UNITED STATES PATENT AND TRADEMARK OFFICE

# Office Action Summary

09/762,223

ANSON ET AL.

Figure 10

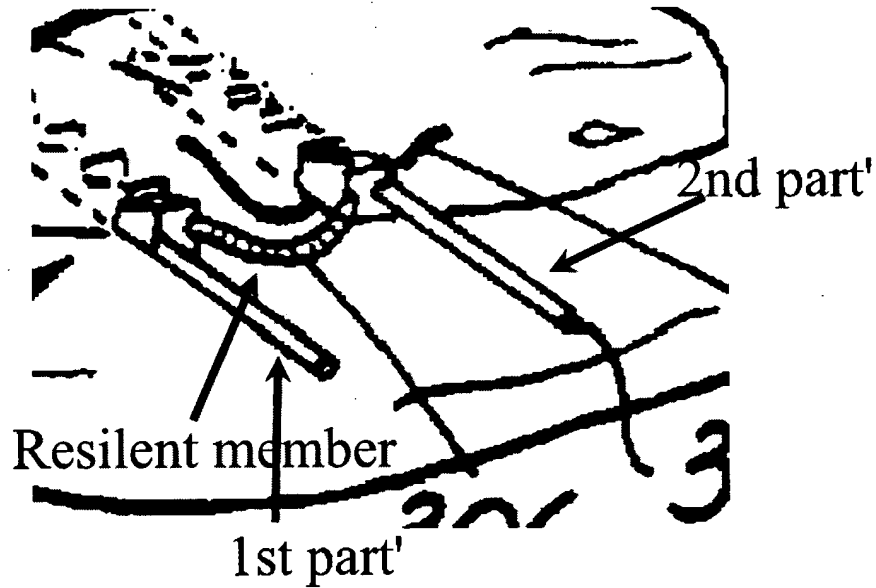
17. Regarding claim 68, the elongate member of the Green device has the capability of being in an open configuration, figure 14, and a retaining configuration, figure 1, where in the 1<sup>st</sup> and 2<sup>nd</sup> parts are closely spaced, wherein the device is biased towards the closed configuration. Further, the elongate member extends between the first and second element and is connected between the first and second ends. The modified Green device could be inserted into a graft-bearing artery to pierce the graft and artery. Once the device, part 1, is completely pushed through the artery, the graft and artery would be maintained between the first and second part where in the device would be in the closed position.

Figure 14

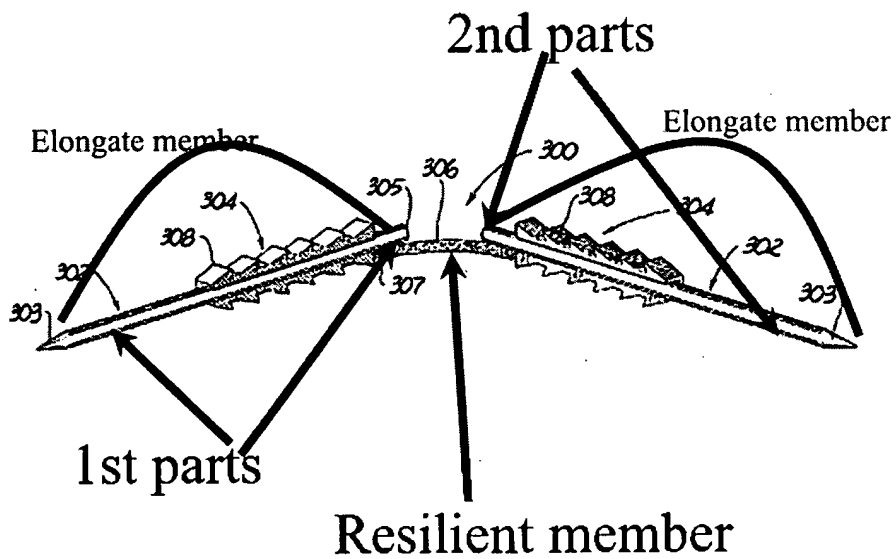
18. Regarding claim 69, the fixator has 2 parts that are sharpened, allowing it to pierce an artery and a graft (see figure 14).
